MICHAEL MILLER BA. (Hons) ARCH. MCIAT
Architectural Consultant

YORK HOUSE, KING STREET, ROBIN HOODS BAY.
2018/0204/LB & 0232/FL

Thank you for your e-mail dated 29th May 2018, I have attached amended drawings for your information:

Drawing No. 193/11a
Date: JANUARY 2018
Scale: 1/50

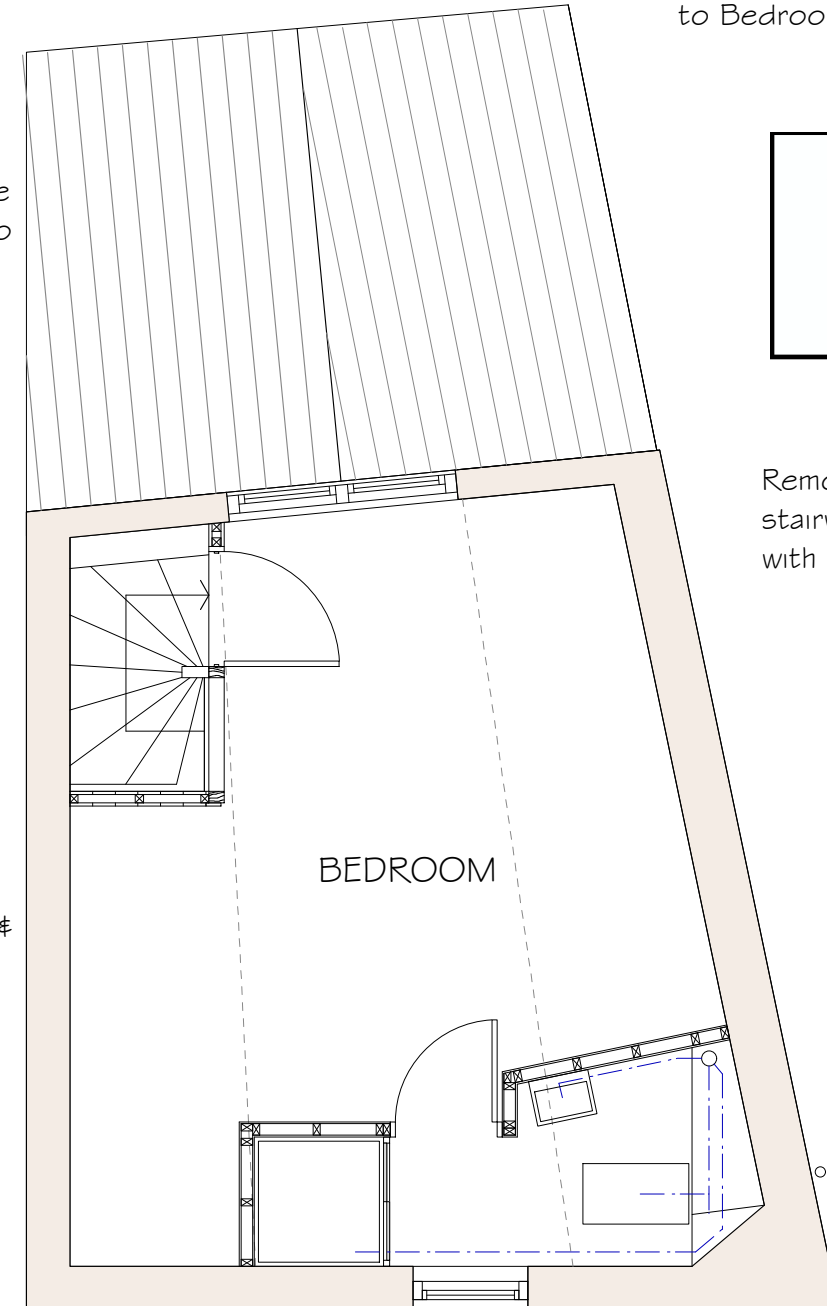
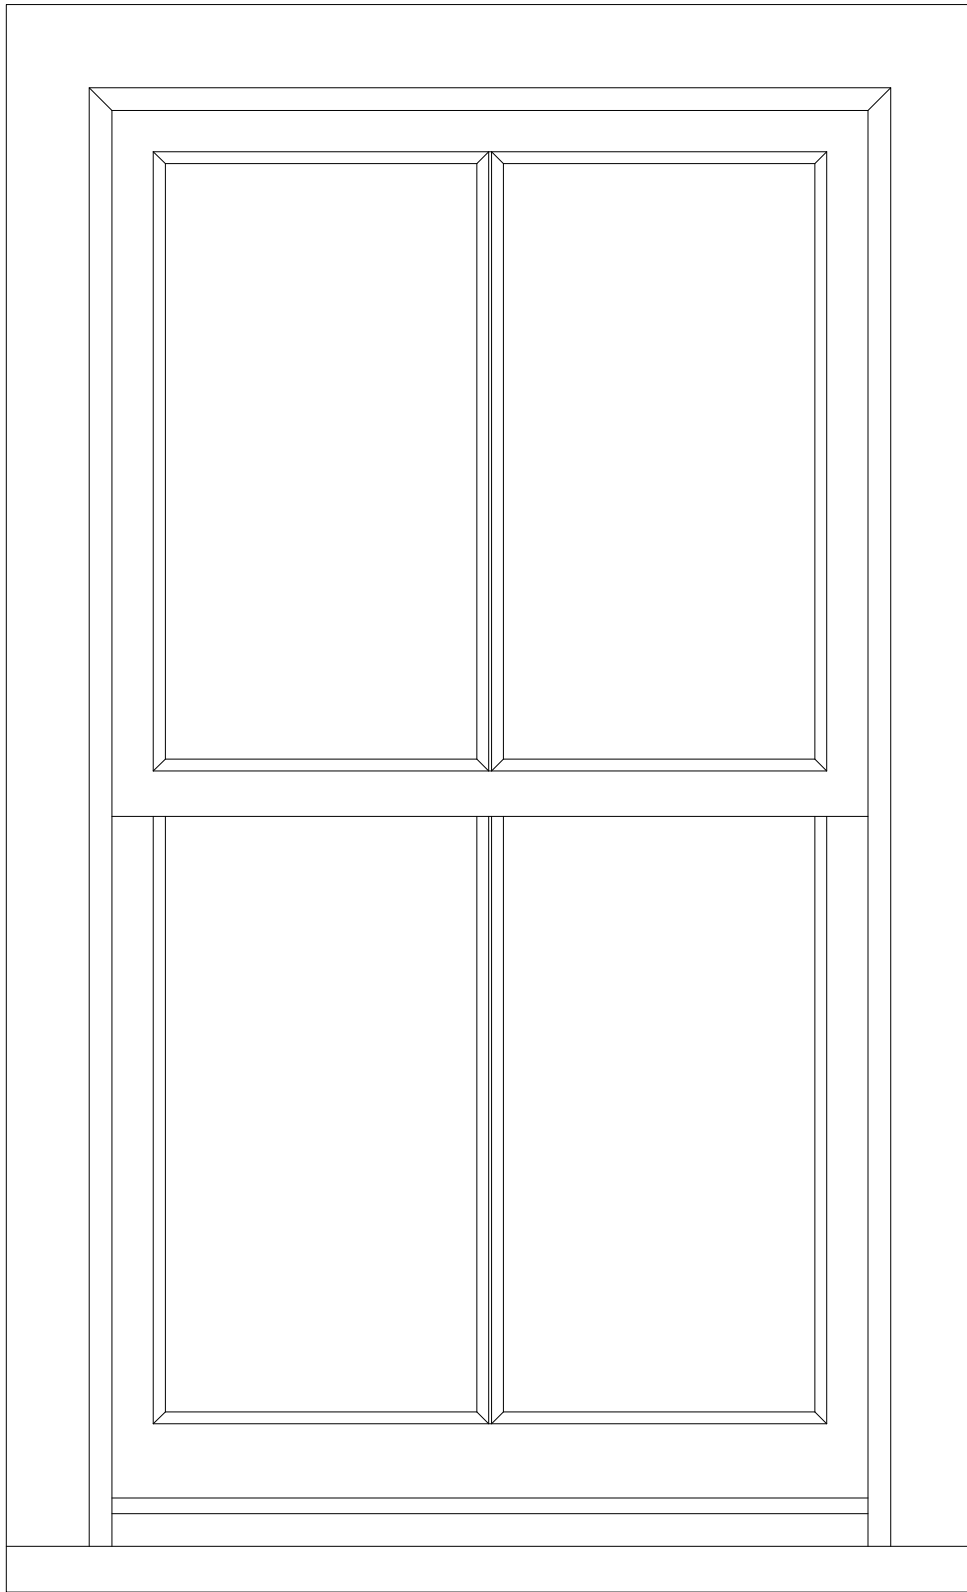
Remove slates & battens from existing roof over First Floor level extension. Lay breathable membrane. New treated sw battens. Re-lay existing slates to correct gauge & lap for size & location. Any additional slates to match. Slates fixed with copper nails. Renew timber barge boards/plates & slate cover battens to match existing.

Notes re: Overhaul & refurbish internal doors. Clarify re-fix extg slates & supplement with matching equivalent. Shower Room ptn boards to Bedroom face.

New Shower Room constructed in timber framed partition wall with moisture resistant plasterboard & plaster skim coat internally. Partition wall to Bedroom face finished with wide timber boards to match elsewhere. Wash basin,wc & shower unit (tray/screen/wall panels /mixer & spray) as client directs. Floor finish as client directs. Layout assumes that tray is on riser kit & waste in duct to s/vp & drop to connection in boiler cupboard below.

2.16. To clarify, the existing slates are to be re-laid. Supplementary slates are to match.

2.41, 2.43. Note added that partition is boarded on Bedroom face.

Drawing No. 193/14a
 Date: FEBRUARY 2018
 Scale: 1/10

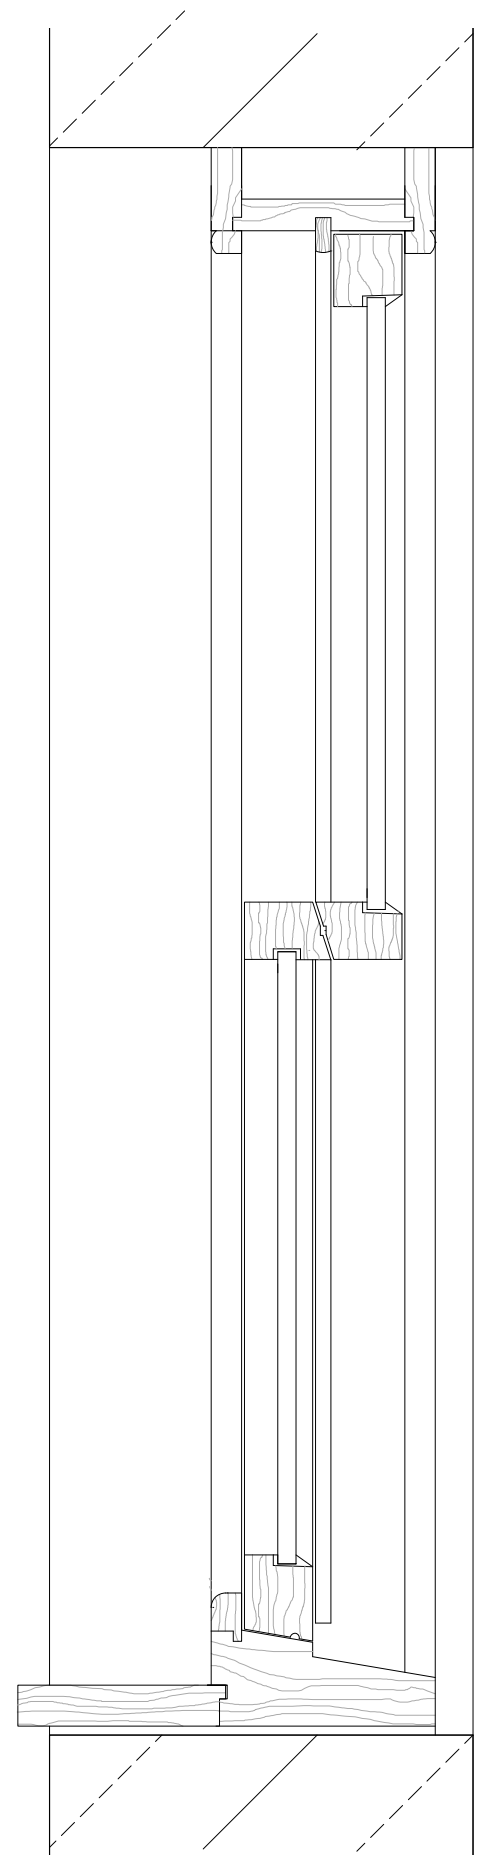
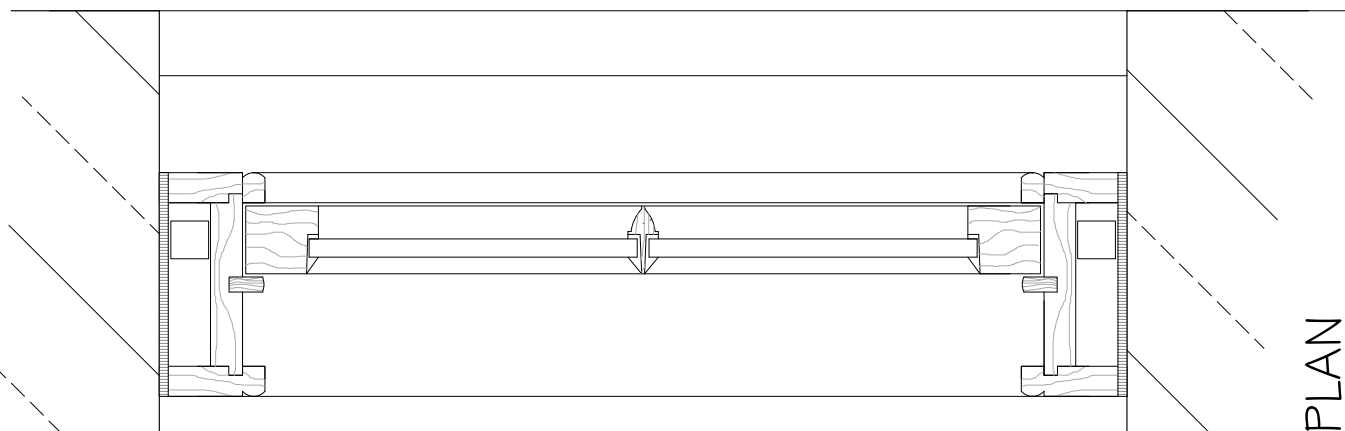
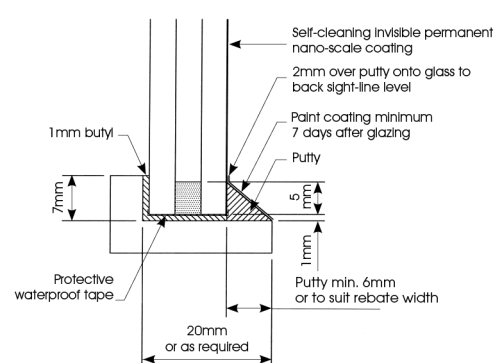
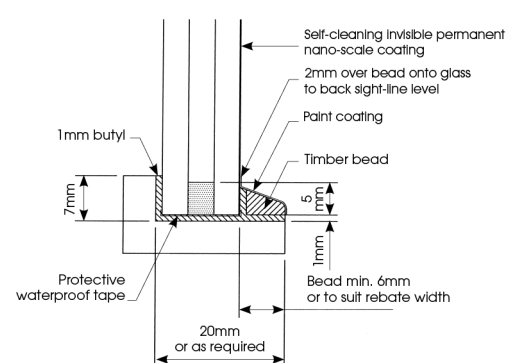
Revision A. 4.6.2018
 Altered to lead weight balanced.
 Frame & box sections/details altered.

Vertical sliding sash window frame to be constructed in accoya for white paint finish. Timber sections as traditional standard sections and lead weight balance in sash box. (Traditional to mean as BS 644 Pt.2).
 12mm Slimlite double glazed unit. Toughened glass both panes. Inner pane Low-E. Argon filled cavity.
 Glazing as Slimlite details

- 2.01. Boundary wall – amended as your proposal.
- 2.02 Drawing amended to lead weight balanced sash. Sections altered.
- 2.03. Ok.
- 2.11 Front door, notes amended as you propose.
